SUNDRY	UREAU OF LAND MANA NOTICES AND REPO		~	5. Lease Serial No. NMLC029410B	
Do not use thi abandoned wei	is form for proposals to II. Use form 3160-3 (API	D) for such proposals.	MAP 1 1 201	6. If Indian, Allottee o	r Tribe Name
SUBMIT IN T	TRIPLICATE - Other inst			7. If Unit or CA/Agre 920003410	ement, Name and/or

1. Type of Well	ег		RECEI	8. Well Name and No. MCA UNIT 310	
2. Name of Operator CONOCOPHILLIPS COMPAN	Contact:	GREG BRYANT YANT@BASICENERGYSER	VICES.COM	9. API Well No. 30-025-24108-0	00-S1
3a. Address MIDLAND, TX 79710	3b. Phone No. (include area of Ph: 432-563-3355 Fx: 432-563-3364	code)	10. Field and Pool or Exploratory Area MALJAMAR

## WELLBORE SKETCH ConocoPhillips Company -- Permian Basin Business Unit

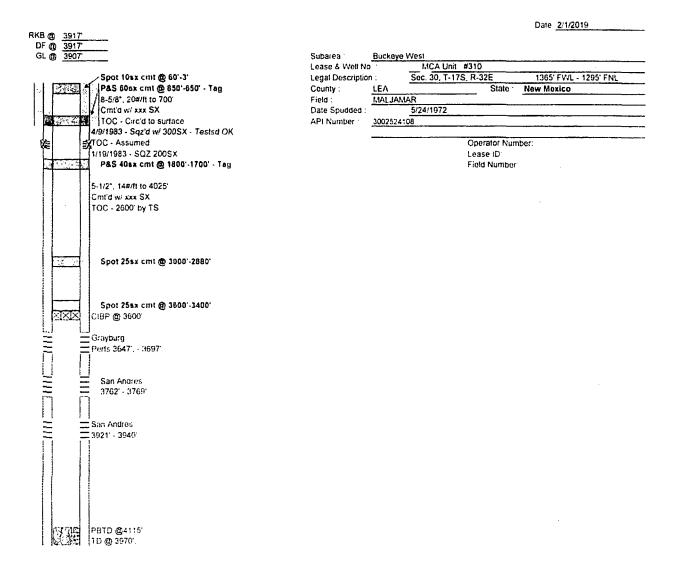
RKB @ 3917'				Date 2/1/2019		
DF @ 3917						
GL @ <u>3907</u>	Subarea Lease & Well N	Buckeye W	MCA Unit #310	······································		
121 1 1 Surface 121/1	Legal Description		Sec 30, T-175, R-32E	1365' FWL - 1295' FNL		
	County	LEA		tate New Moxico		
8-5/8", 20#/It to 700	Field Date Spudded	MALJAMAF				
Cmt'd w/ xxx SX		5	5/24/1972			
TOC · Circ'd to surface	API Number	3002524108	J			
4/9/1983 - Sq2'd w/ 305SX - Testsa OK						
2 STOC - Assumed		Operator Number Loase ID				
		Loaso ID Field Number				
Production 77/8						
5-1/2", 14#/ft to 4025						
Cmt'd w/ xxx SX						
10C - 2500 by TS						
CIBP (0.3000						
			And	575		
Grayburg			i and in the second sec			
Ports 3647' - 3697'			Anhy Sat	690		
			Sat	670		
			Yates			
San Angres			Yntei	1915		
Ξ Ξ 3762' · 3769' ✓			1010			
======================================

-		
			$\frown$	2978		
			Qu	23,-		
= San Andres = 3921 - 3940			•			
			10	3333		
			6B	393 3		
				<b>P</b>		
			<b>^</b> .	3718		
			SA			
PBTD @4115'				3864		
i tersenet intra fanske 📼			Lev.	00-1		
			Cov .
